LSC RESPONSES TO EPC TIS REDLINE COMMENTS

Mr. John Mick
Mayberry Phase 1

October 22, 2021
Transportation Memorandum

Exhibit 1

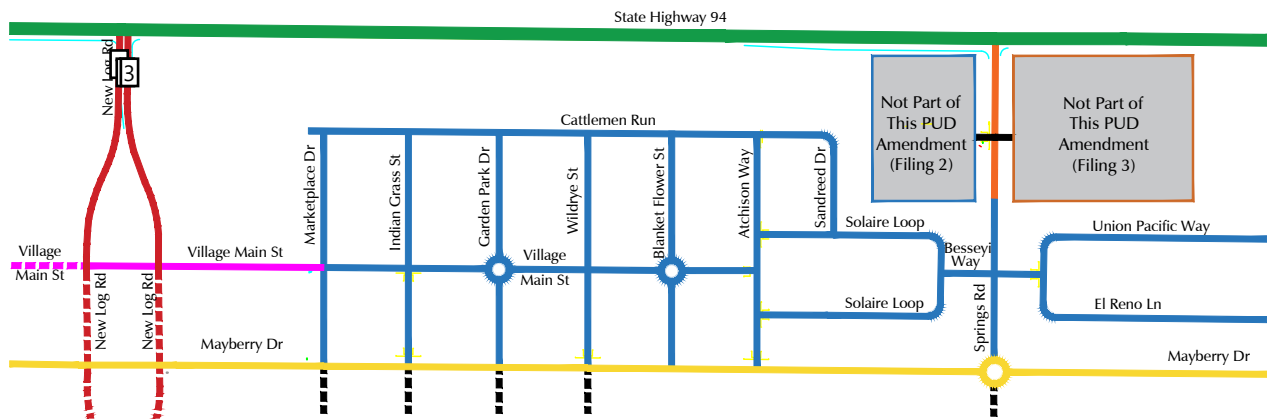
Please explain the reasoning for the classification of the southerly portion of this road to urban local. Springs road is the main access for the commercial developments to eventually go west at New Log Rd. The wider pavement section of a collector road may be needed for the commercial traffic that will utilize this roadway. Per the PUD development plan submitted it appears that only the ROW width is changing from 65' to 60' but the paved width is staying the same. Please clarify if the only change proposed in terms of the roadway cross section is the ROW width. Please be aware that design attributes of this roadway will be required to meet Collector standards.

LSC Response: This comment has been addressed in the updated report. The proposed ROW is 65'.
